Our Reference: 23.064  
TCC Reference: MCU26/0016  
HF

### **Response to Information Request Development Application for Material Change of Use – Tourist Park 772 Black River Road, Black River and formally identified as Lot 24 on SP305779**

## Information Request

# TRAFFIC IMPACT ASSESSMENT

Figure 3: Turn Warrant Assessment (RPDM)

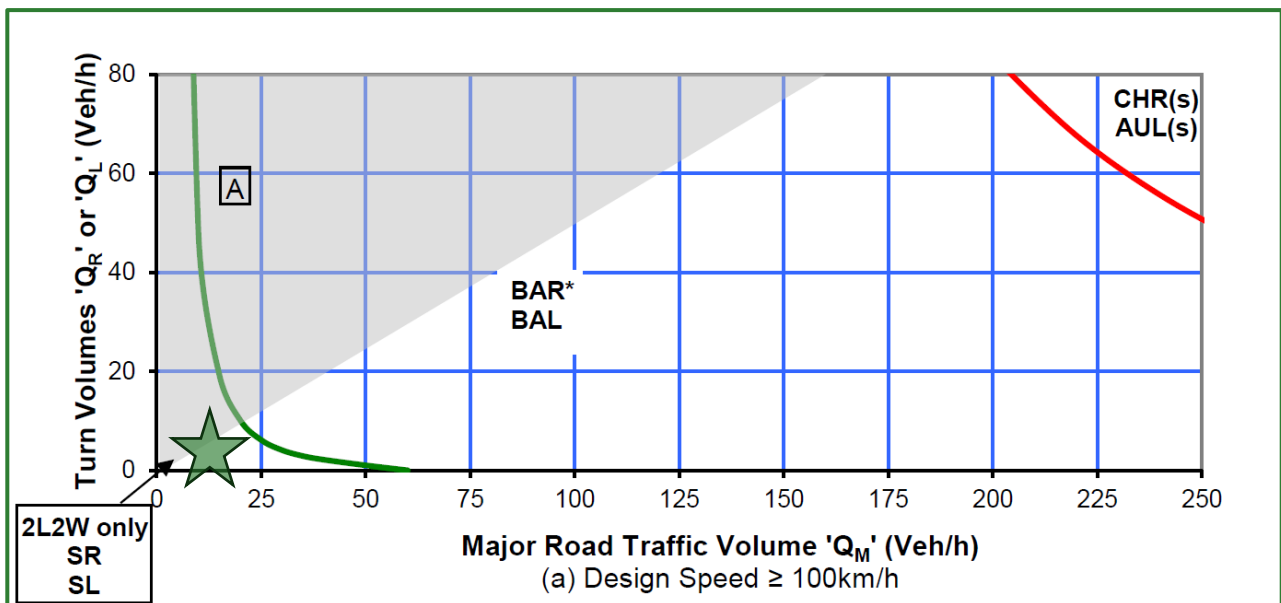
- Address site access safety including adequate sight line clearances and impacts on existing traffic facilities such as heavy vehicle turning paths.
- Confirm that sufficient queuing capacity is provided at the site access in accordance with the RTA's Guide to Traffic Generating Developments.
- Consider and recommend a Basic Right Turn Treatment (shoulder widening opposite the access point), as this represents the typical AUSTRROADS minimum standard.

When the peak turning demand of seven (7) vehicles per hour is assessed against a background through volume of approximately ten (10) vehicles per hour using Figure A.11(a) for design speeds  $\geq 100$  km/h (see Figure 3), the access operates well within the intended serviceability limits for simple left-turn and simple right-turn movements. Accordingly, no additional turn lane treatments (such as a basic left or basic right turn) are required, and the existing access arrangement is considered appropriate to safely accommodate the expected turning movements without additional infrastructure works from a traffic engineering

perspective. Specifically, provision of a Basic Right Turn Treatment for a peak right-turn demand of approximately two (2) vehicles per hour would represent a disproportionate response to the identified traffic impacts.

In summary, the very low turning and through traffic volumes mean the access operates safely and comfortably within the thresholds for simple left and simple right turn movements, and no additional turn treatment is warranted.
